Work Order ID 86823

D3303-041 HEAD REST

DRAWING NO. D3303	TITLE HEAD REST	REV. B	DART AEROSPACE LTD ENGINEERING ORDER		D.E.O. NO. D3303-B-1	SHEET NO. SHEET 1 OF 1	SCALE NTS
DRAWN AJS	CHECKED <i>[Signature]</i>	MFG. APPR. <i>[Signature]</i>	APPROVED <i>[Signature]</i>		DE APPR. <i>[Signature]</i>		
DATE 08.10.15	DATE 08.10.15	DATE 08/10/16	DATE 08/10/16		DATE 08/10/16

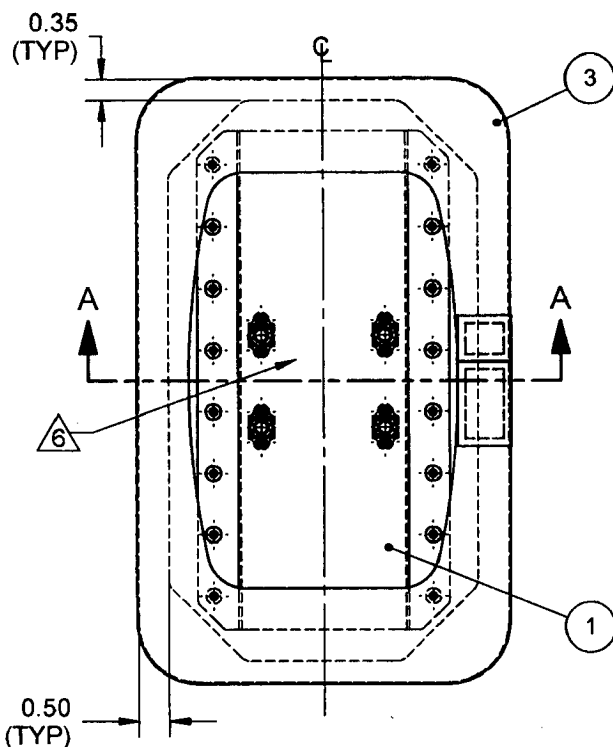
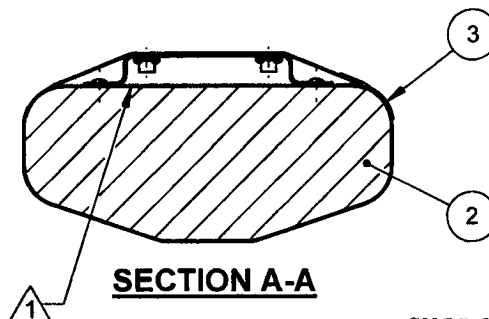
SHEET 1 ADD 1300L ADHESIVE BY 3M TO NOTE 1 AS FOLLOWS:

- 1) BOND D3305-1 FOAM TO D3303-043 BRACKET ASSEMBLY USING 3M 1300 OR 1300L ADHESIVE (0.002" TO 0.010" THICK) IN ACCORDANCE WITH MANUFACTURER'S INSTRUCTIONS

- 1) BOND D3305-1 FOAM TO D3303-043 BRACKET ASSEMBLY USING 3M 1300 ADHESIVE (0.002" TO 0.010" THICK) IN ACCORDANCE WITH MANUFACTURER'S INSTRUCTIONS
